Proposed Option:

Bell Wharf Upgrade, modified from 2008 Plan, the implementation and possible adjustment of the 2008 Plan for Carols Wharf, and a simple extension to Eastern Wharf.

Detailed Proposal Imagery of Bell Wharf

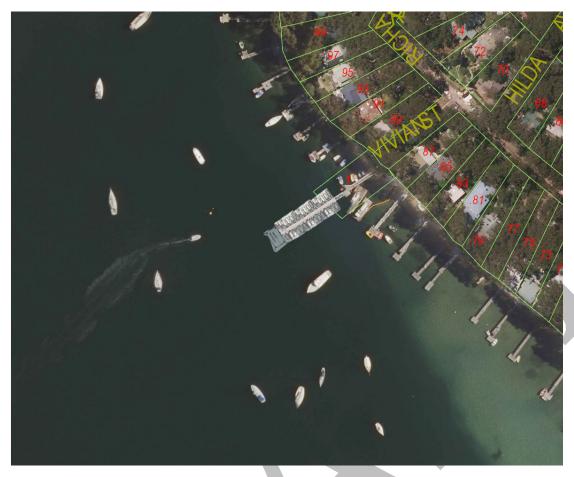
- From the existing shed, add a ramp to a pontoon into the deeper waters 8 posts in length (approximately 40m), adding 30 tie-ups (15 east and 15 west). This is a modest extension considering the usage and available space, and makes excellent use of Bell Wharf's proximity to deep water.

- Possibly relocate the bins to the end of this extension after consultation with service providers.
- At the end of this extension, include the 2008 planned Ferry Accessible Pontoon landing.

- To not include the inclusion of tie-up rings and ladders (or associated moorings such as sea anchor, chain, pulley, rope etc.) for the existing wharf section.

- Keeps the heritage value of the existing wharf and shed.
- To retain the stairs as an important safety aspect should anyone fall from the pontoon.
- To include cleats or other tie up equipment to indicate and restrict the number of spots allocated.

- To consult with the community in relation to the design aspects, such as lighting, dimensions, safety measures and acoustics.

Detailed Proposal Imagery of Carols Wharf

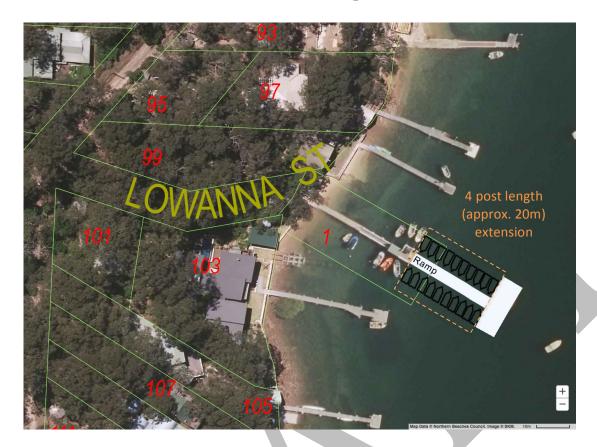
- That council adopt the Plan of Management (2008) for Carols Wharf.
- That the redevelopment incorporate an extension to the eastern arm to utilise the deeper water and thus increase capacity (an additional 16 spaces from to 2008 POM).
- To possibly do this works in two stages: Stage 1 being the western arm and ferry pontoon as can be done in existing reserve boundary; Stage 2 soon after if the time to adjust the reserve is prohibitive for it to all be done concurrently.
- That the arm extensions be a floating pontoon style, keeping the weather conditions in mind (strong and fierce winds/swells from the east).
- To possibly include a breakwater to the Eastern side.

- To not include the inclusion of tie-up rings and ladders (or associated moorings such as sea anchor, chain, pulley, rope etc.) for the existing wharf section.
- Keeps the heritage value of the existing wharf and shed.
- To retain the stairs as an important safety aspect should anyone fall from the pontoon.
- To include cleats or other tie up equipment to indicate and restrict the number of spots allocated.
- To consult with the community in relation to the design aspects, such as lighting, dimensions, safety measures and acoustics.
